Rotorua District Plan Change Two – Pukehāngi Heights

**STATEMENT OF PLANNING EVIDENCE OF DAVID JEFFERY MARSHALL ON
BEHALF OF TE ARAWA LAKES TRUST**

MEMORANDUM

Date: 17 September 2020
To: Te Arawa Lakes Trust
Subject: Plan Change 2 – Stormwater Review
From: Sean Finnigan

Figure 1: Utuhina Flow Data

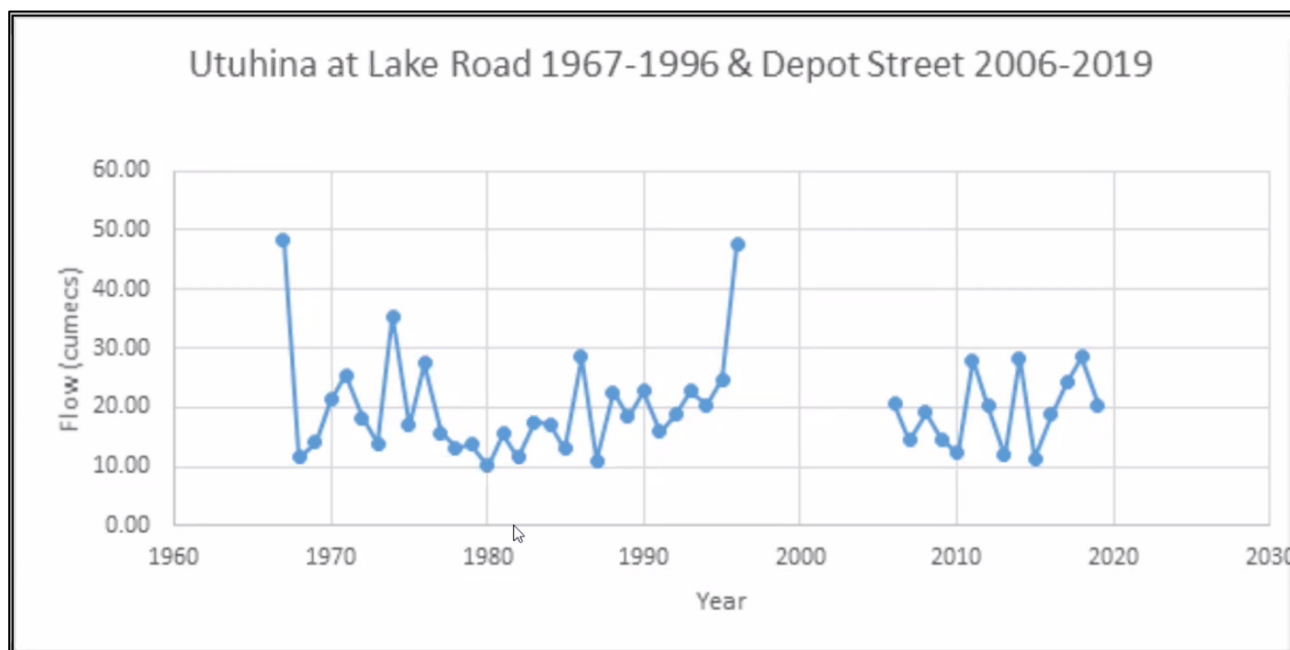
As recorded in the Joint Witness Statement – Stormwater dated 1 September 2020 (**JWS**), an issue was raised about shortcomings in WSP’s flood frequency analysis which was based on data from around 2005-present (15 year record), and which gave an estimated 100 year peak flow of 36m³/s at the Utuhina Stream Depot Rd rainfall gauge. The data used by WSP in their analysis is from the right hand side of the graph in Figure 1.

In contrast, BOPRC consider (and I agree) that use of only the last 15 years of data gives an under-estimate of peak flows, as it misses multiple more severe flood flows from earlier years (see left hand side of Figure 1). If the earlier data is included, BOPRC obtained a 100 year peak flow of around 55m³/s.

Figure 2: WSP Flood Modelling Results (September 2020)

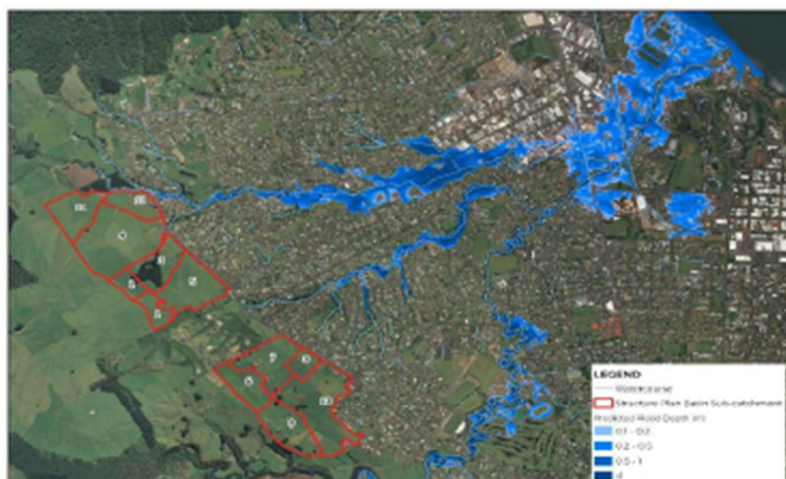
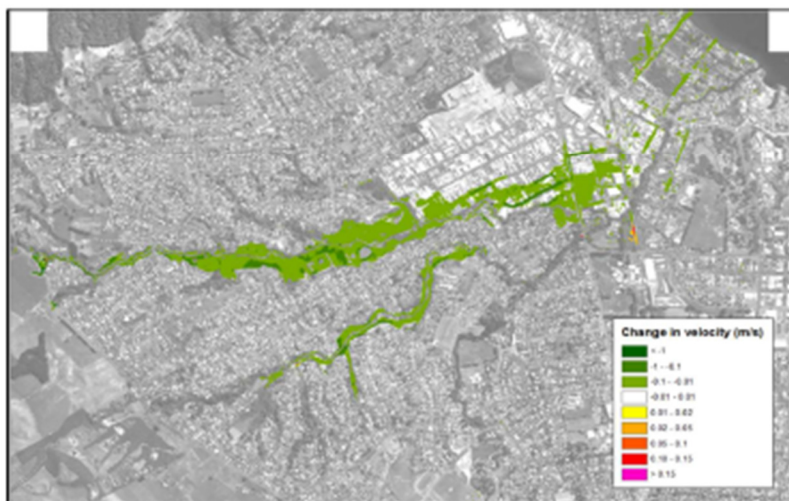
Their modelling covered 10% AEP (10 year), 2% AEP (50 year), 1% AEP (100 year) and 0.2% AEP (500 year) events, with the 1% and 0.2% events also allowing for climate change. They produced difference maps which are included in Appendices B and C of the WSP Stormwater report. These difference maps show the change in flood level and velocity relative to the existing situation. They generally show a decrease in flood level of 10-100mm for all scenarios. Three typical maps are shown below. The first shows the existing predicted flooding for the 1% + climate change storm. The second and third are difference maps for depth and velocity respectively, where the different colours show the modelled changes in flood level and velocity. All green colours represent decreases in flood level.

In my opinion, with both Scenarios 15 and Scenario 16, further consideration needs to be given to the effect of detention basin discharges resulting in prolonged elevated flows in the downstream network, compared with the pre-development situation, this being a consequence of the greater volume of post-development runoff. The main potential effects of prolonged elevated flows are:

- Reduction in the capacity of stormwater pipe systems discharging directly to watercourses, due to elevated water levels in the stream slowing down the rate of discharge (tailwater effect).
- Increased stream channel erosion, as it is these more common storm events that tend to shape the stream channel.

Whilst the WSP Stormwater report does refer to these issues, they are not discussed in detail. In my opinion, these are important issues, that should be considered as part of an overall holistic approach to catchment management, rather than simply focusing on flooding.
